Summary of Decisions Requested to Proposed Private Plan Change 11: Bardowie Industrial Precinct by Topic

Sept / 2018

Appendix 1 – Submission point 13/33

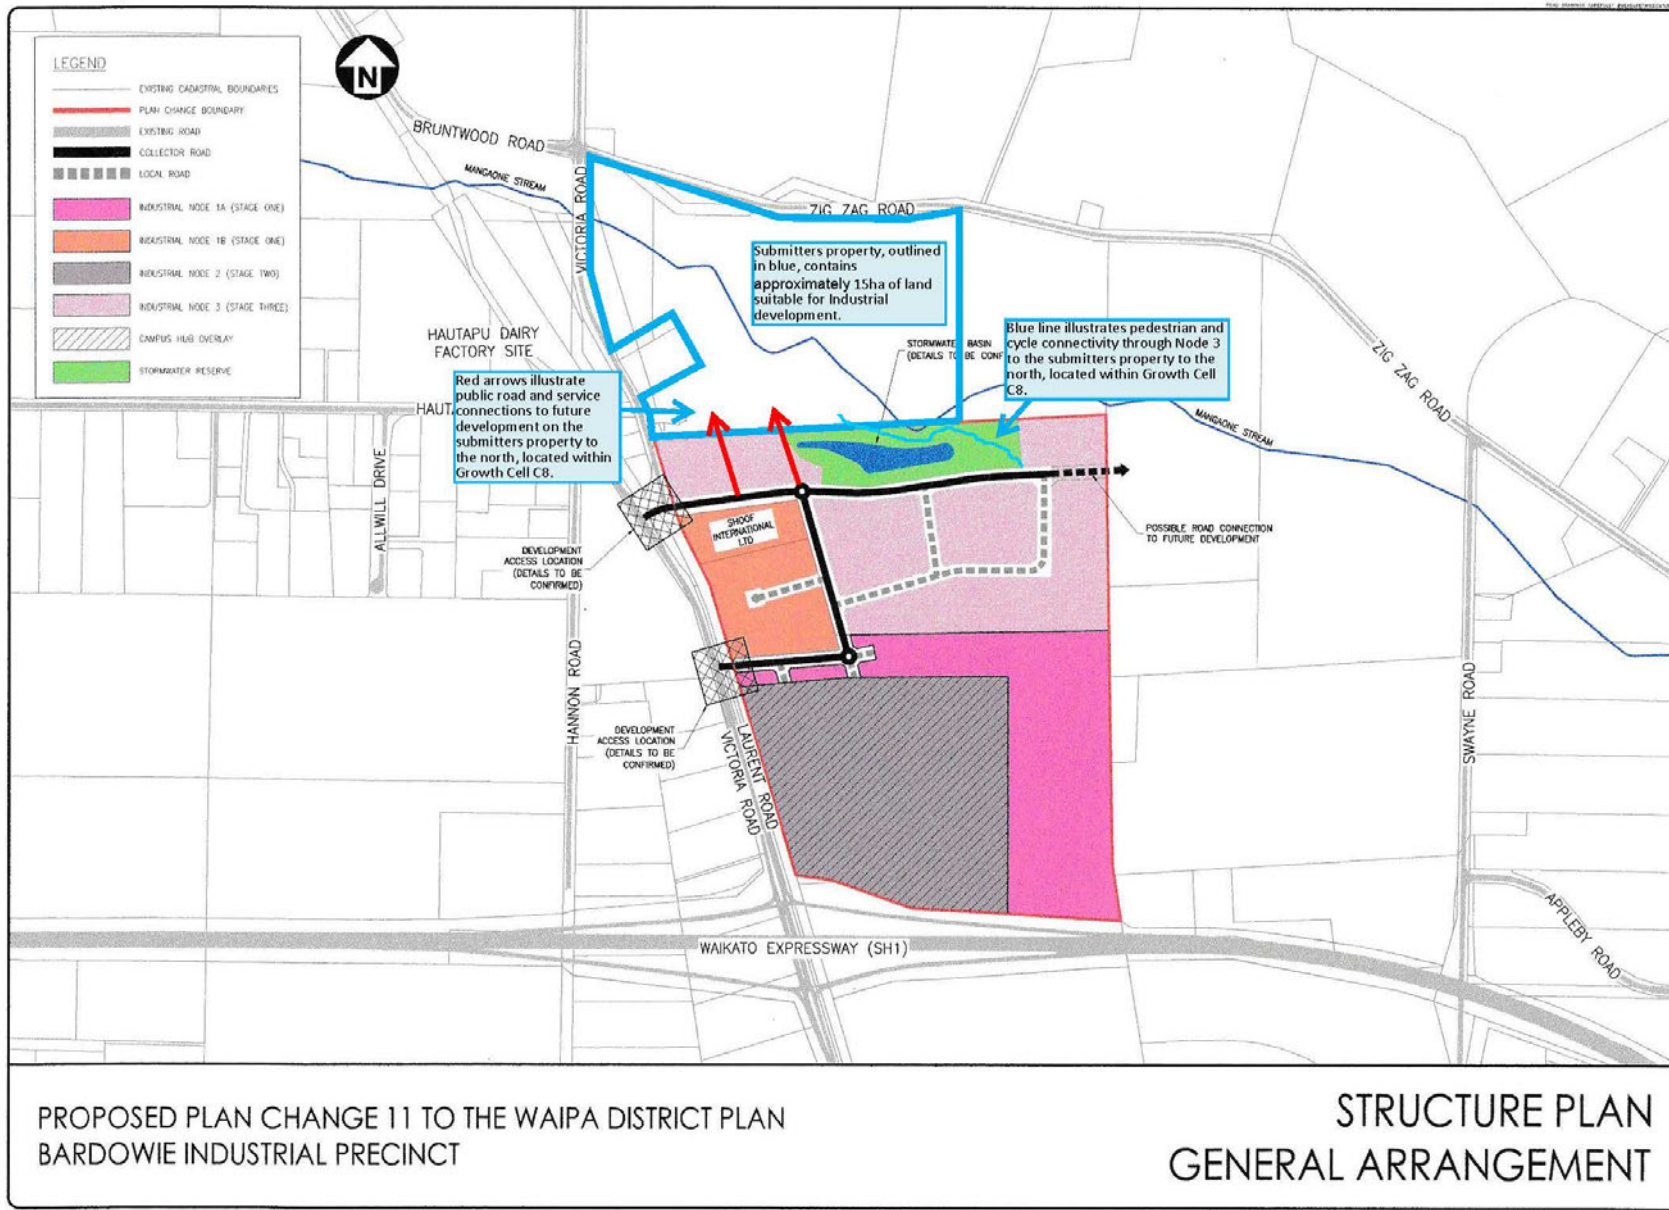
S19.2.22 Electricity	13/32	Support in part	Support on the condition that electrical services are buried underground.	Reject S19.2.22 as notified. Accept submitters amendments. S19.2.22 Waipa Networks has confirmed that electricity can be supplied to the Bardowie Industrial Precinct, <u>and all electrical services within the Bardowie Industrial Precinct Structure Plan Area will be underground.</u>
S19.2.26 Structure Plan	13/33	Support in part	Concerned that no connectivity to the adjoining land to the north, owned by the submitter, and located within Growth Cell C8 as currently shown in Appendix S1 of the Waipa District Plan.	(i) Reject Appendix S19 – Bardowie Industrial Precinct Structure Plan as notified. (ii) Accept submitters proposed amendments to Appendix S19 – Bardowie Industrial Precinct Structure Plan. (<i>Submitters amendments are illustrated on the plan in Appendix 1 of this document</i>)
